# CITY PLANNING COMMISSION

- APPLICATION:
1. Negative Declaration
  2. Amend South Pocket Community Plan from Low Density Residential to Low Density Multiple Family
  3. Rezone 29± acres from Agricultural (A) to Garden Apartment (R-2B) (Section 13)
  4. Tentative Map (P84-066)

PROPOSAL: The applicant is requesting the necessary entitlements to subdivide 29± vacant acres into one airspace lot for development of 544 condominium units.

APPLC. NO. P84-066

ELEVATION STUDY  
 TYPICAL BUILDING CLUSTER

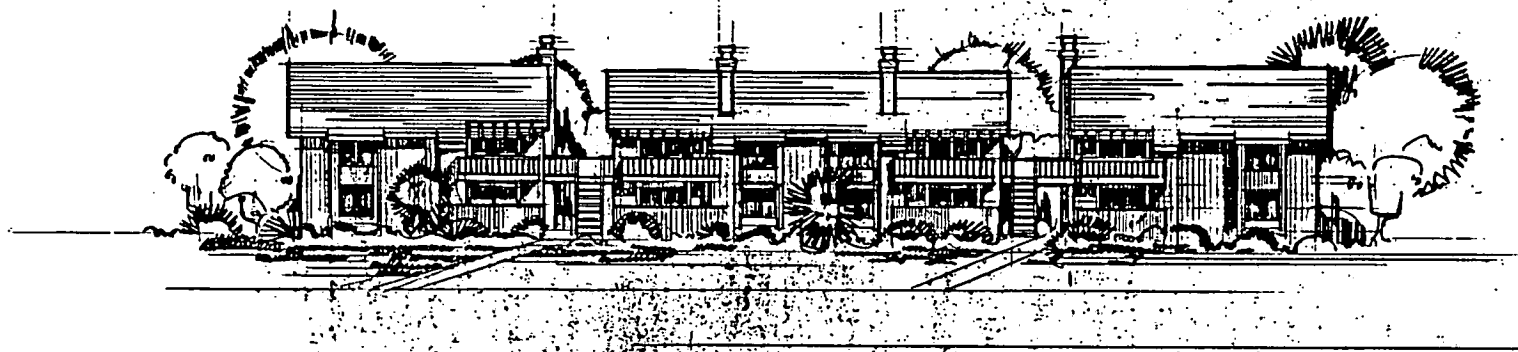
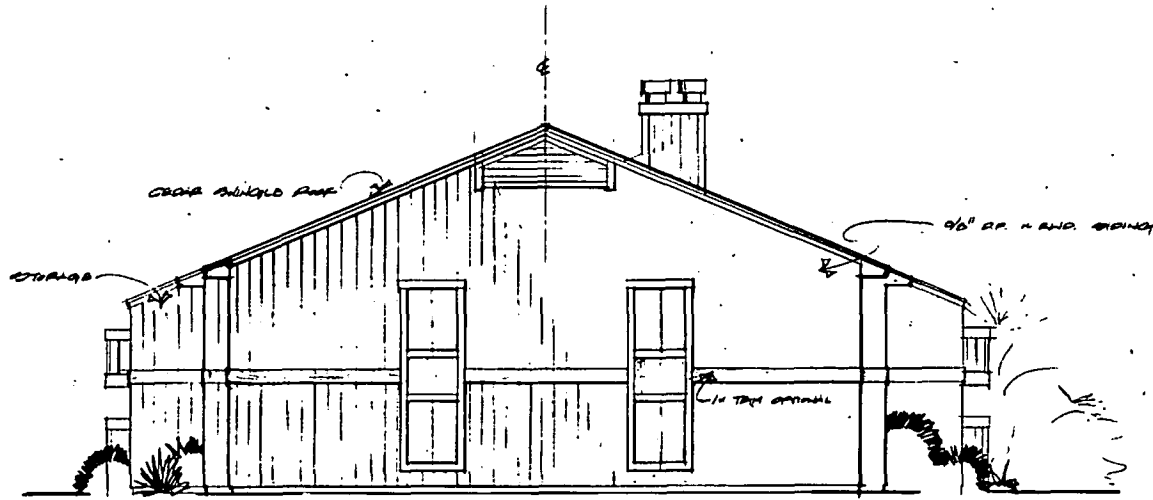
The applicant has submitted only two elevations for two different structures. Staff, therefore, cannot determine whether two story units might impact future single family units to the east by creating a view into side or rear yards. In addition, the end elevations do not coincide with the floor plans. Reduced copies of the elevations and floor plans have been submitted.

### SCHEMATIC SITE PLAN

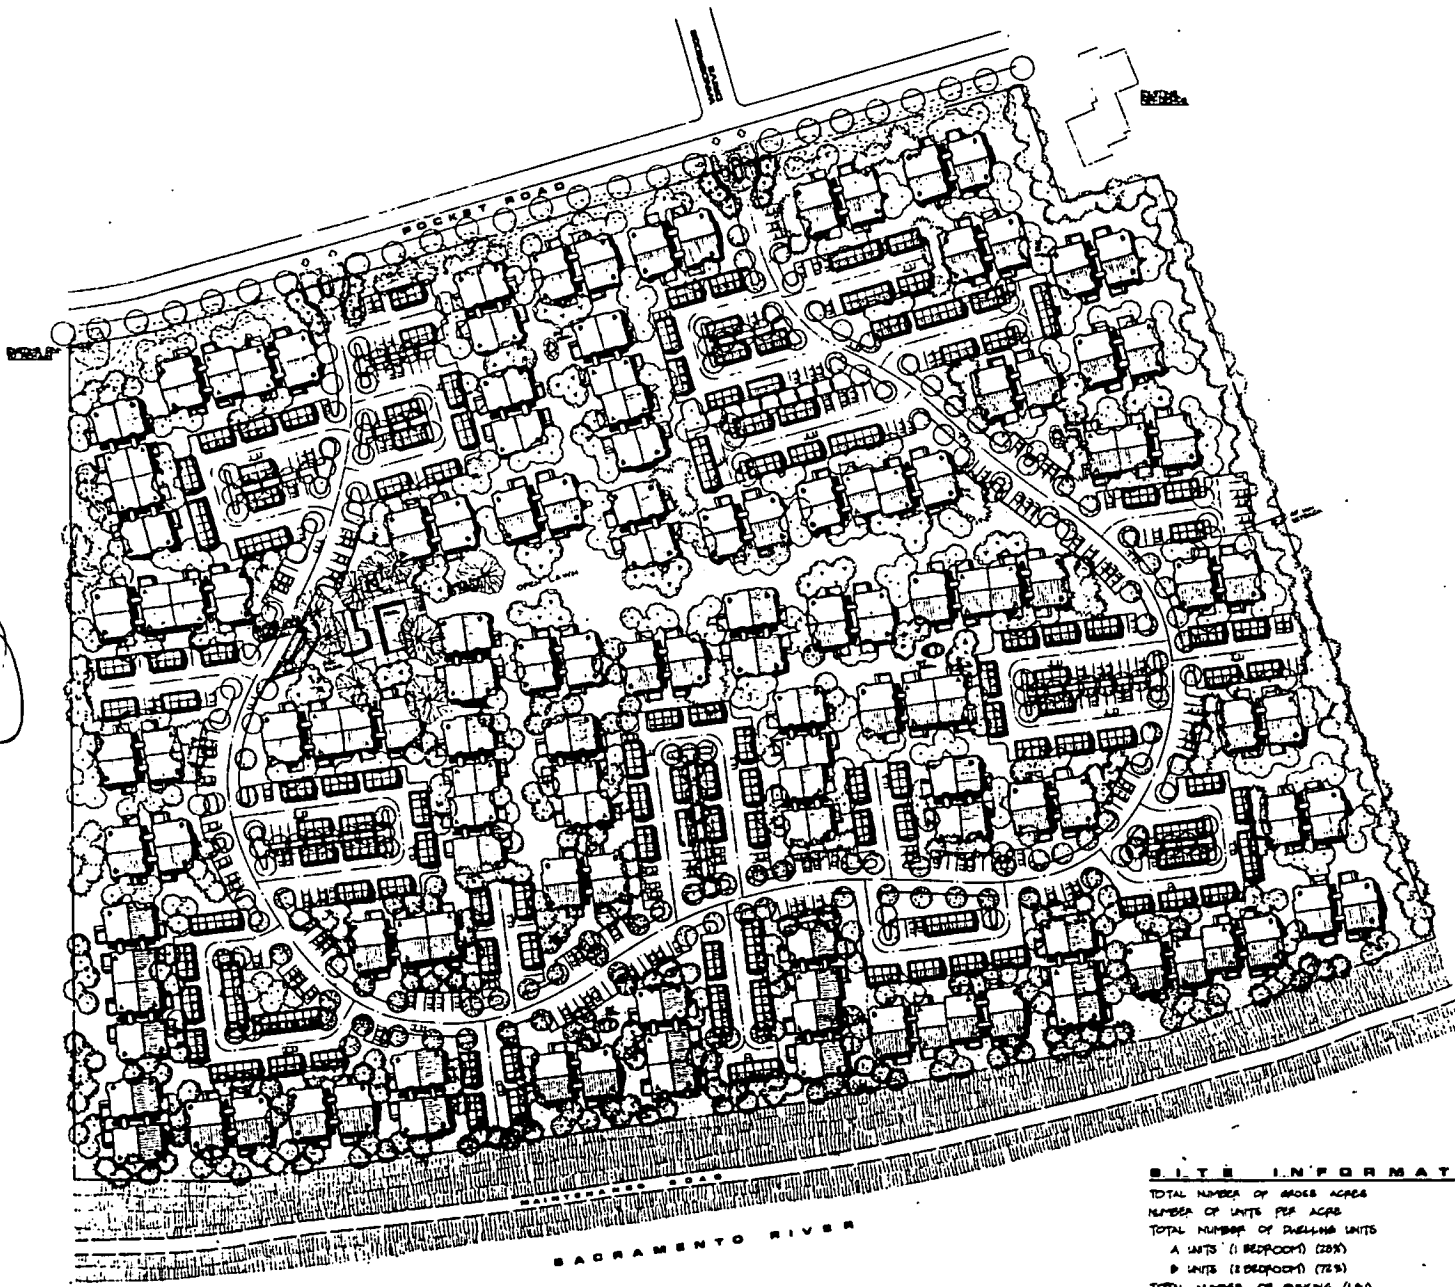
3. The applicant has submitted a site plan, floor plans and elevations. These plans, however, lack sufficient detail to evaluate the proposed project. There also appears to be inconsistencies in correlating the site plan to the floor plans and elevations. For instance, the site plan appears to indicate four- and eight-plex units, all one bedroom in size. However, the floor plans and elevations indicate one and two bedroom units and the environmental questionnaire indicates all units to be two bedroom. The site plan indicates a 20 to 40 foot setback from the eastern property line to the proposed two story structure.

4. In order for the staff to provide a comprehensive analysis and accurate report for the Commission to review, the applicant should submit accurate

detailed site plans, elevations and floor plans. The site plan should indicate the breakdown of units with one and two bedrooms, structural sizes and eliminate potential overview into neighboring properties. Detailed elevations should include all four sides of the structures, exterior colors and materials and roofing materials.
